OFFICIAL STAR CLASS MEASUREMENT CERTIFICATE**Sec. C.****—INSTRUCTION TO CERTIFIED MEASURERS—**

YACHT NO. 3405

OFFICIAL STAR CLASS MEASUREMENT CERTIFICATE

Report from International Measurement Committee

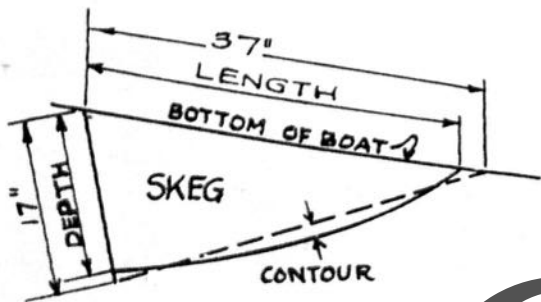
I feel you are making an error in the measurement of the skegs of the Lippincott Boats.

The measurement required is a physical one - not a projected dimension. The measurement is taken along the bottom from the center of the rudder post to the edge of the cast iron keel.

The measurement is quite unimportant actually with keels as far aft as they are placed in modern STARS but please give us the correct dimensions in the future.
